Subject: Information Report, NHTSA No. 99V-033.003

Recall Bulletin

Subject: FCCC Tie Rod Assemblies

MODELS AFFECTED: Freightliner specific MT35 and MT45 Custom Chassis Step Vans, manufactured between May 2, 1998 and November 11, 1998

Fig. 1, Tie Rod End

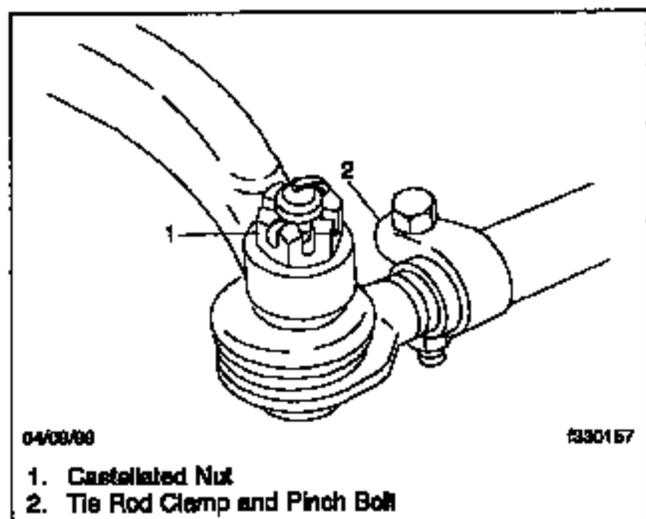
1. Park the vehicle, set the parking brake, then chock the rear tires.
2. Remove the tie rod from the vehicle.
 - 2.1 Remove the cotter pin and the castellated nut from the tie-rod ball stud. See Fig. 1.
 - 2.2 Remove the tie-rod end from the tie-rod arm.
 - 2.3 Repeat the procedure at the other end of the tie rod. Then, remove the tie rod from the vehicle.
3. Install the new tie rod onto the tie rod arms.
4. At one end of the tie rod, install the castellated nut and tighten 80 lbf-ft (108 N-m). Install a new cotter pin through the ball stud and the slot in the castellated nut. If the cotter pin cannot be installed, tighten the nut so the next slot in it lines up with the hole in the ball stud. *Do not back off the nut.*
5. Repeat the procedure at the other end of the tie rod.
6. Go to "Toe-in Checking."

1. Loosen the tie-rod clamp pinch bolts. See Fig. 1.
2. Set the pointer on the scale end of the trammel bar to read 1/16-inch (1.6 mm) toe-in. Lock the pointer in place.
3. Position the trammel bar at the front of the tires. Make sure the pointer at the opposite end (without the scale) of the bar is centered on the scribed line of the tire.
4. Adjust the length of the tie rod by turning the tie-rod tube. Adjust the tie-rod length so the pointer on the scale end of the trammel bar is centered on the scribe line of the tire.
5. If the vehicle is equipped with power steering, turn on the engine. Turn the steering wheel left and right to center the steering linkage.
6. Make sure the front tires are straight ahead. Shut down the engine, if applicable.
7. Check the toe-in measurement again.

Fig. 2, Wheel Toe-In (overhead view)

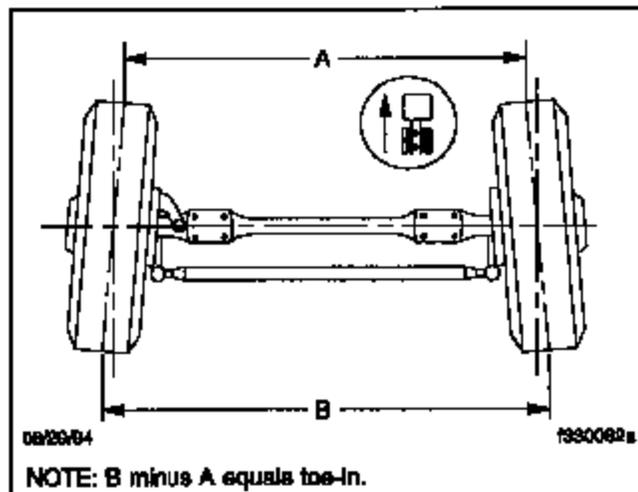
Toe-in is the difference between the measurement taken at the front and rear of the tires. See Fig. 2. The front measurement should be 1/16-inch \pm 1/16-inch (1.6 mm \pm 1.6 mm) less than the rear measurement.

Fig. 3, Trammel Bar Positioning

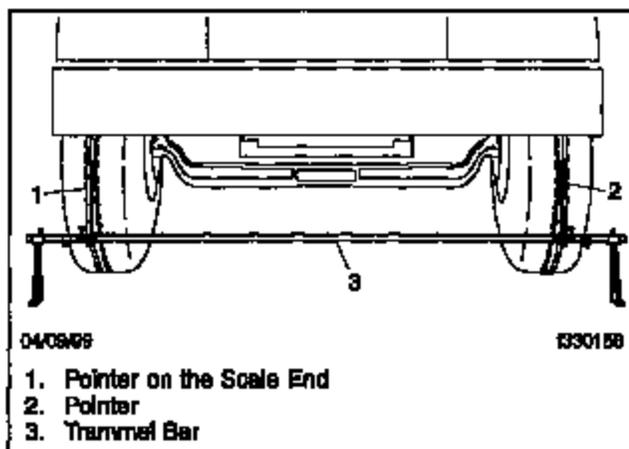
- Adjust the pointer on the opposite end of the trammel bar so it lines up with the scribed line on the other tire. Lock the pointer in place.
- Remove the trammel bar from the rear of the tires. Then position it at the front of the tires so the pointer on the end without the scale is centered on the scribed line on the tire. See Fig. 3.
